## Permit Modification Request

The following submittal has been prepared by the Department of Energy and Los Alamos National Security, LLC (DOE/LANS) to request eleven (11) permit modifications to the November 2010 Los Alamos National Laboratory (LANL) Hazardous Waste Facility Permit (Permit). These modifications have been prepared as self-implementing Class 1 permit modifications and Class 1 permit modifications requiring prior approval as described in the New Mexico Administrative Code, Title 20, Chapter 4, Part 1 (20.4.1.900 NMAC) (incorporating Code of Federal Regulations [CFR], Title 40 § 270.42(a) and (d)). LANL's Environmental Protection Agency (EPA) identification number is EPA ID No. NM0890010515.

The permit modifications include changes to the emergency equipment listings and instructions for inspections, revisions to figures and descriptions of structures and equipment at Technical Areas (TA) 50 and 54, and correction and clarification of statements within the existing Permit to reflect various changes occurring in support of waste management activities. These modifications do not include requests to remove any emergency equipment without replacement, changes to the ca

**Figure G.12-1: Technical Area 54, Area G, Pad 11 Outdoor Container Storage Unit Grid Sampling and Additional Sampling Locations**

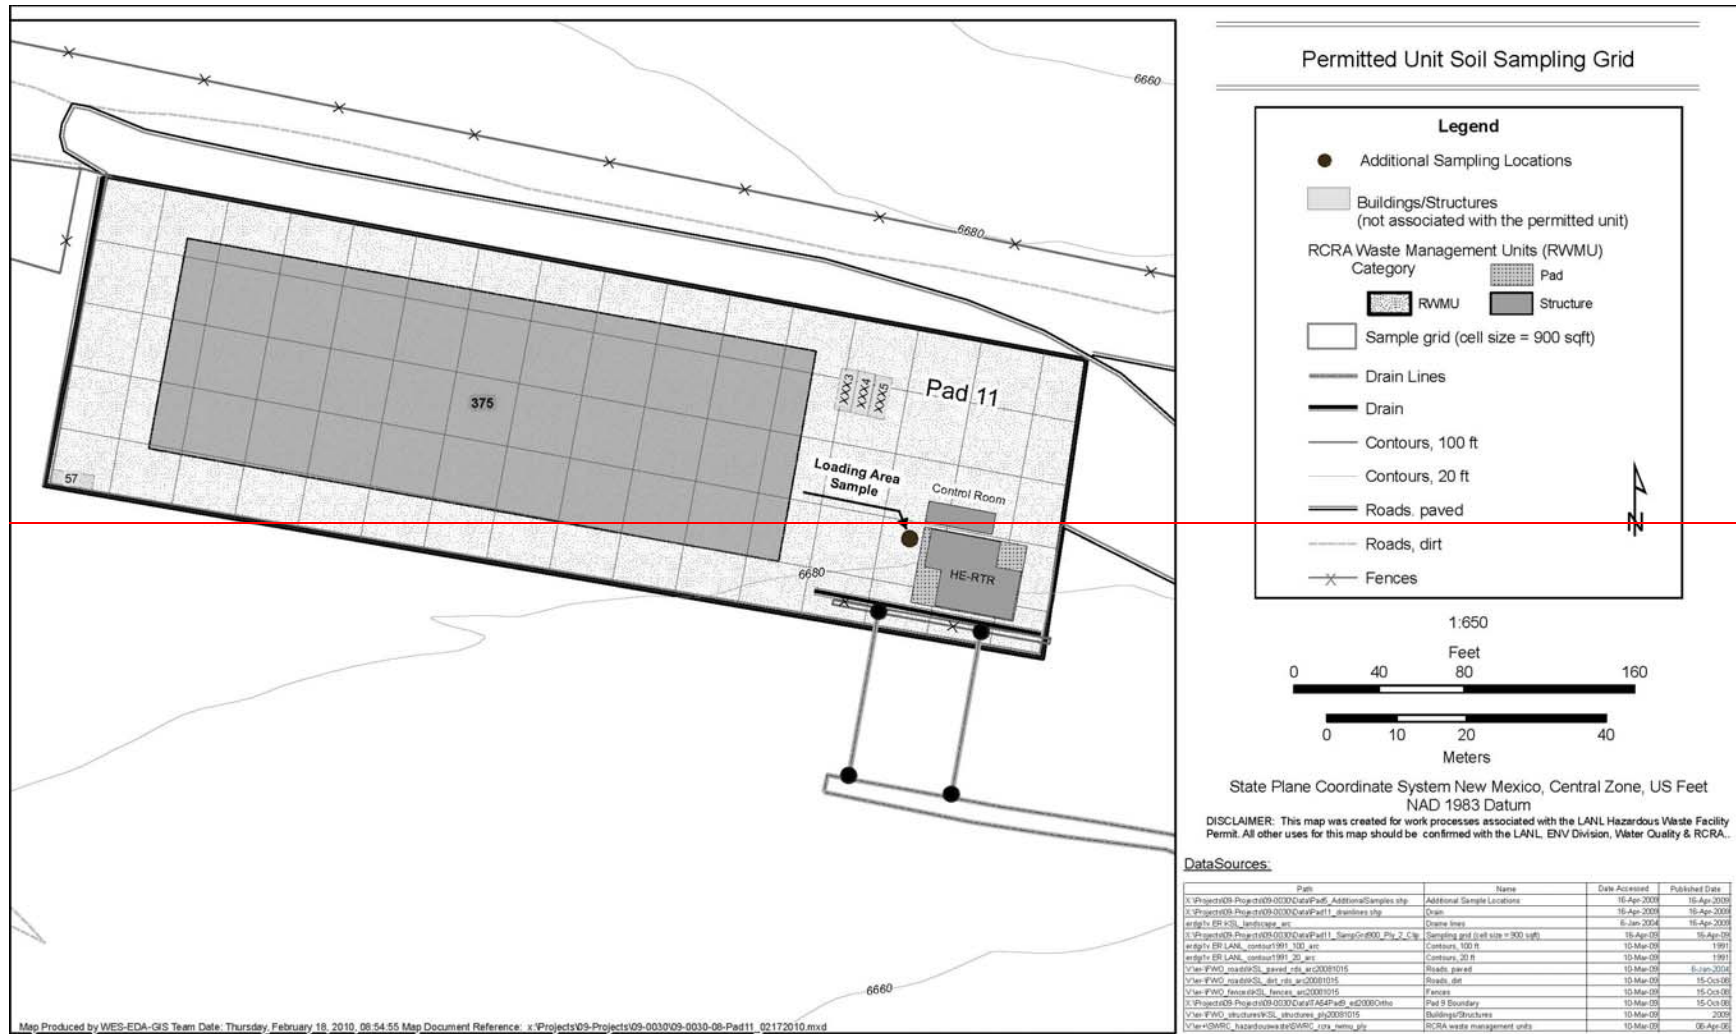
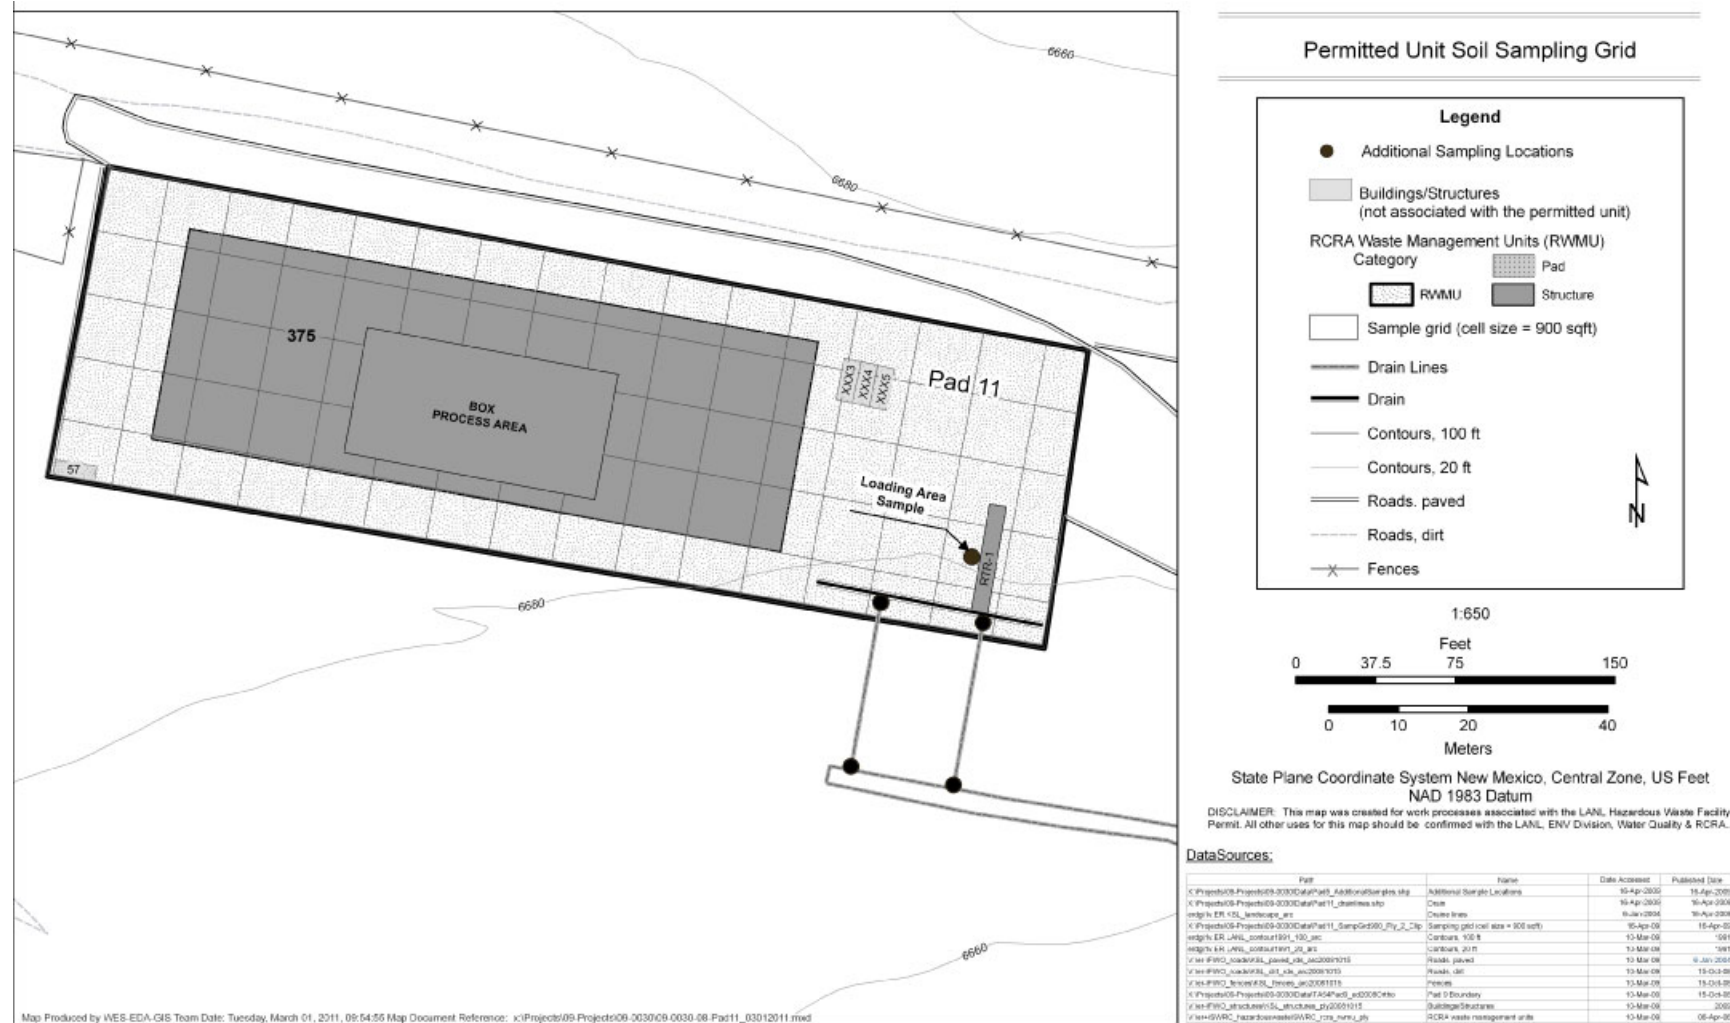
The RTR1 is used for X-ray examination of the contents of a waste drum and is currently located as structure 362 on TA-54 Area G, Pad 9. In support of current planning activities for the mixed transuranic waste characterization procedures the RTR1 will be moved from TA-54, Area G, Pad 9 to the permitted unit at TA-54, Area G, Pad 11. The move from Pad 9 to Pad 11 is anticipated to be completed by June 2011. Depictions and descriptions of the RTR1 and its capability, where applicable, have been added to the Permit in redline-strikeout or as revised figures. Descriptions have been added to Section A.4.2.9 in Attachment A (*TA – Unit Descriptions*); Sections 2.0, 5.2.2, & 5.3.2 in Attachment G.12 (*TA-54, Area G, Pad 11 Outdoor Container Storage Unit Closure Plan*); and Table J-1 in Attachment J (*Hazardous Waste Management Units*). Figure G.12.1 in Attachment G.12 and Figures 8, 27, & 36 within Attachment N (*Figures*) have been revised to illustrate the RTR1 on eastern side of the permitted unit. This request is consistent with the requirements in Section 3.1(3) of the Permit for changes to structures that will manage hazardous waste at a permitted unit. Therefore, a Class 1 modification requiring prior Agency approval pursuant to 40 CFR § 270.42(d)(2)(i)) is being requested.

Figure 23  
Technical Area (TA) 50, Building 69, Indoor and Outdoor Container Storage Units

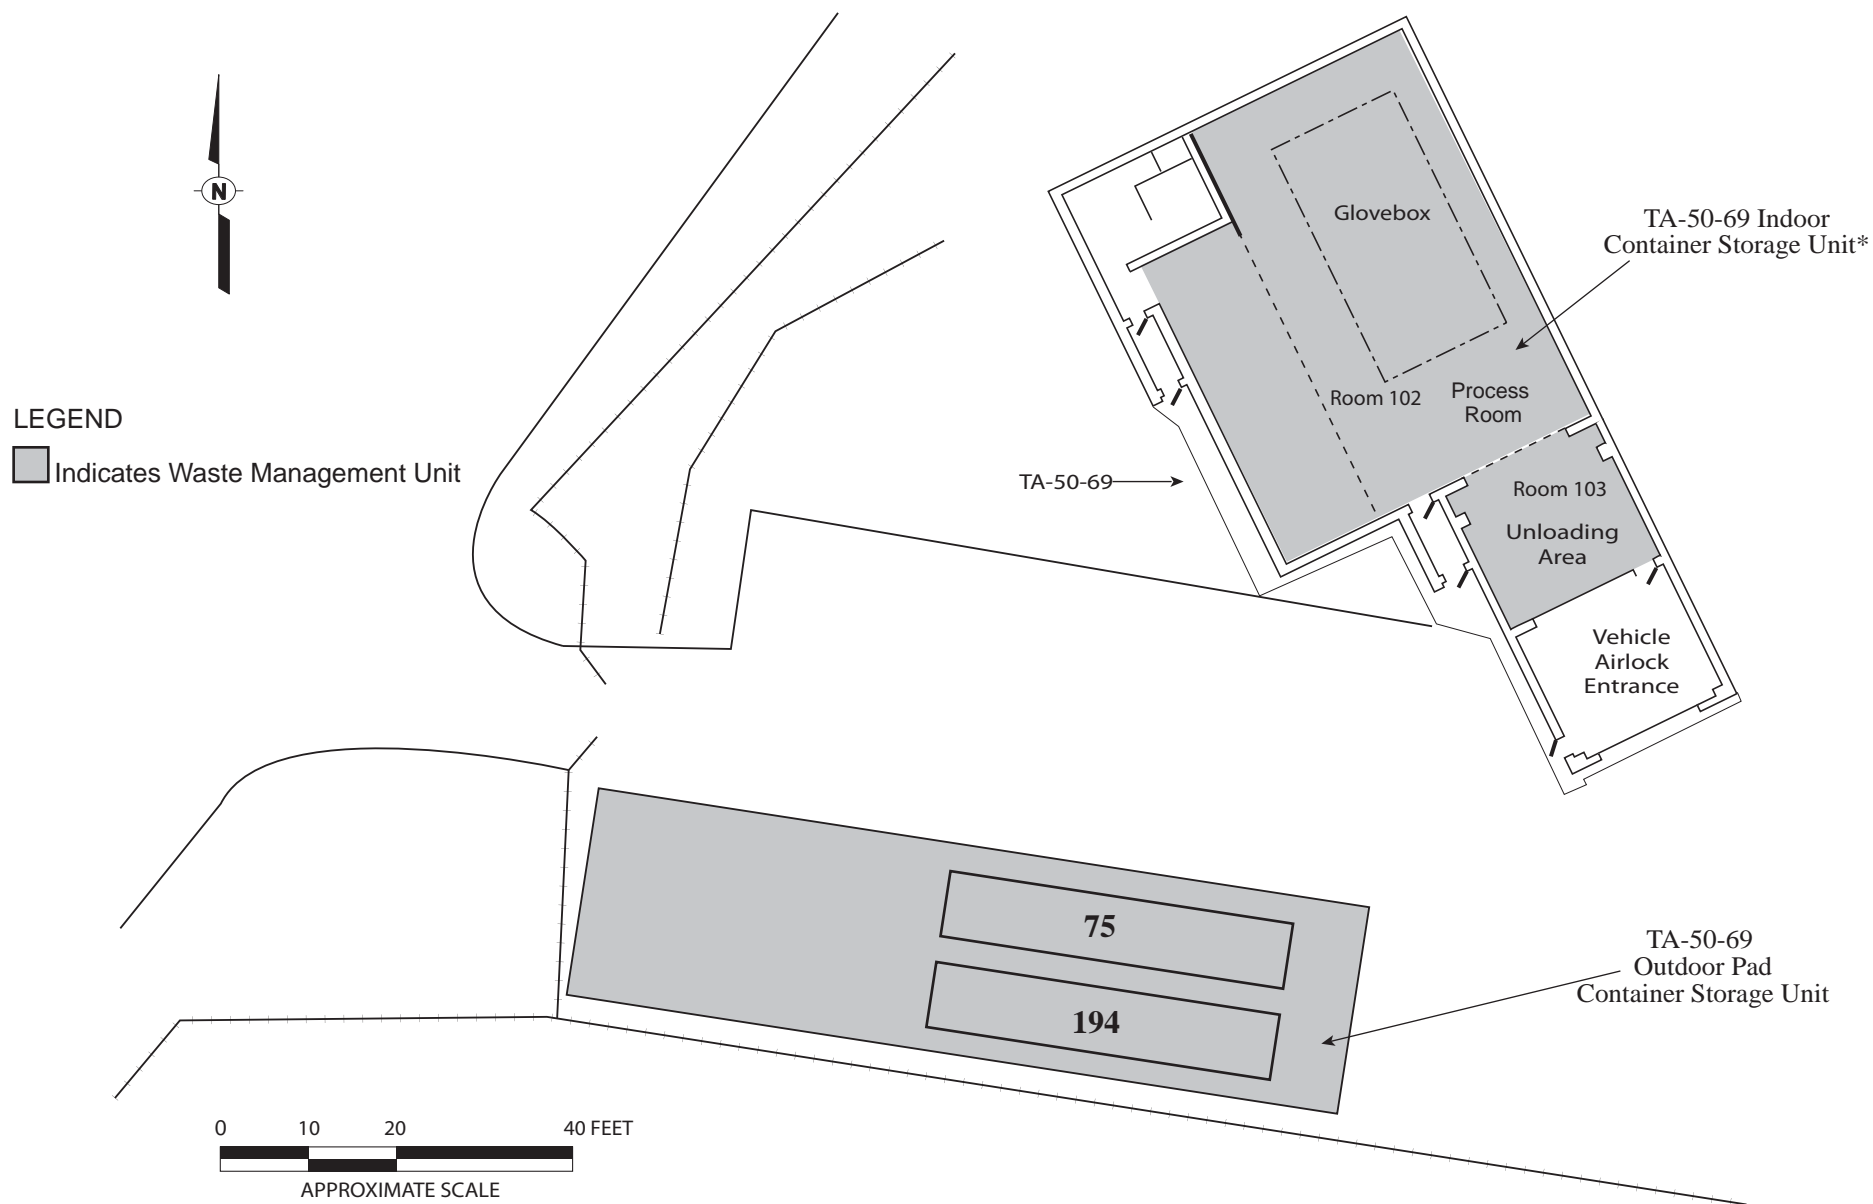
The figures currently within the Permit incorrectly identify one of the transportainers at the TA-50-69 Outdoor Unit as structure number 154. Figure 23 within Attachment N (*Figures*) and Figure G.5-1 within Attachment G.5 (*TA-50-69 Outdoor Container Storage Unit Closure Plan*) have been revised to correctly identify this structure as 194. The purpose of this permit modification makes an informational changes and is being implemented as a Class 1 permit modification pursuant to 40 CFR § 270.42(a).
